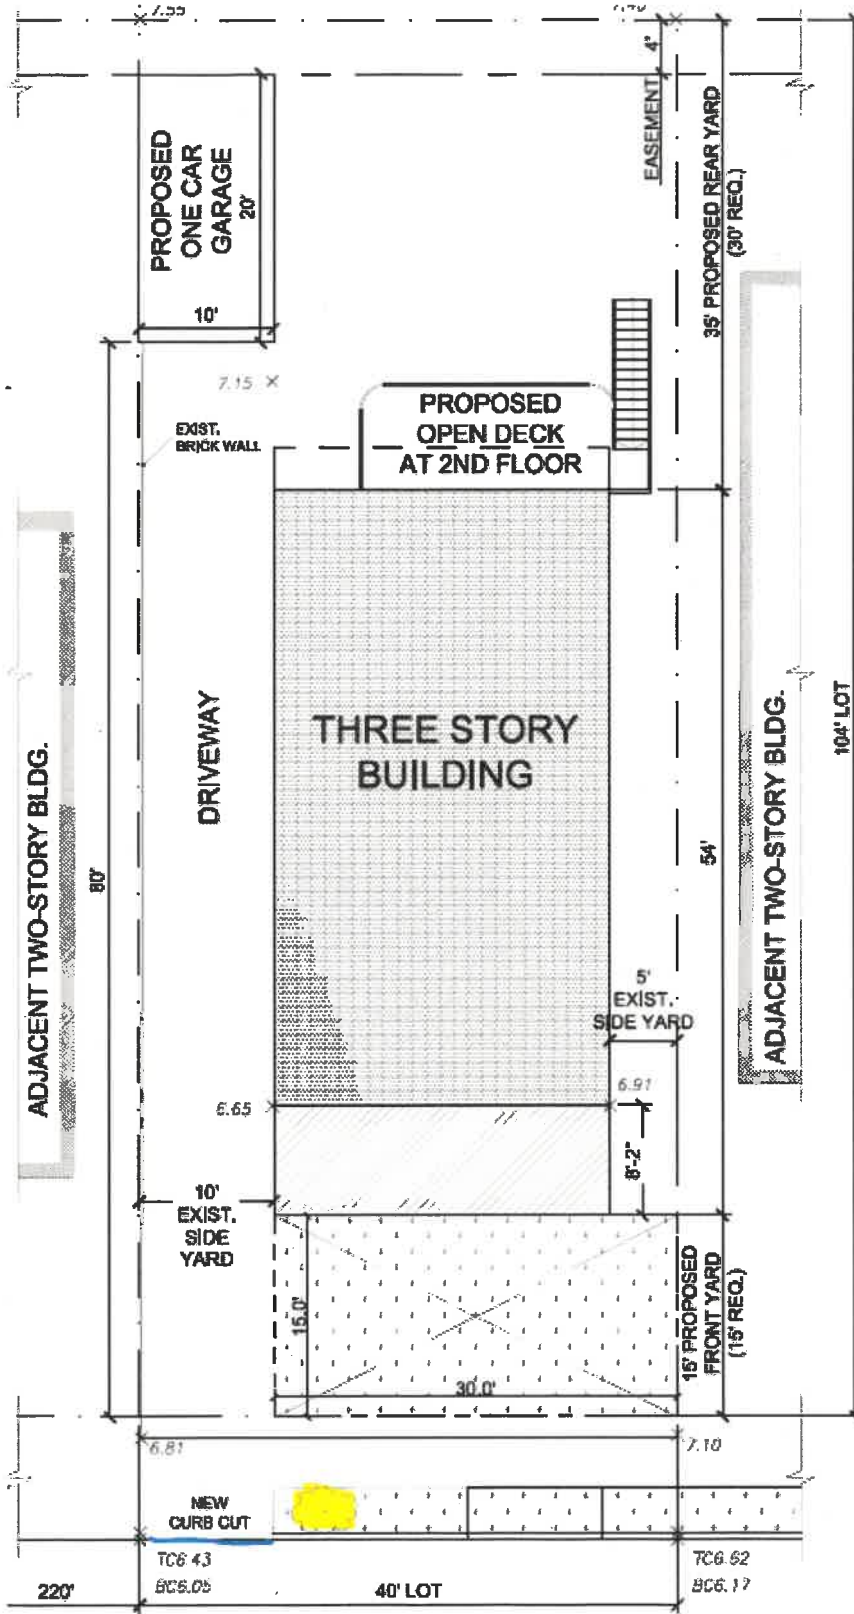
12. We are planning to propose Alt.1 to meet NB regulations in order to vertically enlarge an existing one-family building in R3-1 district, NOT a Special District, but Flood zone. In addition, we are planning to propose NB to build an accessory enclosed garage in order to get an additional 300 sq.ft for the residence per Z.R. 23-142(c). Existing Street Tree (yellow on site plan below) is located about 3' from the related curb cut (blue), which would be necessary to create for the aforementioned garage.

- a. Considering that the street tree is a healthy mature 14" diameter, is there any way to get approval contrary to the required 7' separation between curb cut and street tree (per NYCDOT 6.0.1) or the only option is removal?

The DOB cannot alter the rules and regulations of the DOT. As a result, the 7' required minimum distances between edge of a driveway splay and the tree will be required unless approved otherwise by the DOT.

Moreover, regarding removing the tree, the DOT's INSTRUCTIONS FOR FILING PLANS & GUIDELINES FOR THE DESIGN OF SIDEWALKS, CURBS, ROADWAYS AND OTHER INFRASTRUCTURE COMPONENTS states that, "No tree shall be planted in or removed from the public right-of-way without a written permit from the Department of Parks and Recreation (DPR)."

This is confirmed by BC 3309.11 {Protection of trees} that states, "No trees outside the property line within the public right-of-way shall be disturbed or removed without the permission of the commissioner of the department of parks and recreation..."
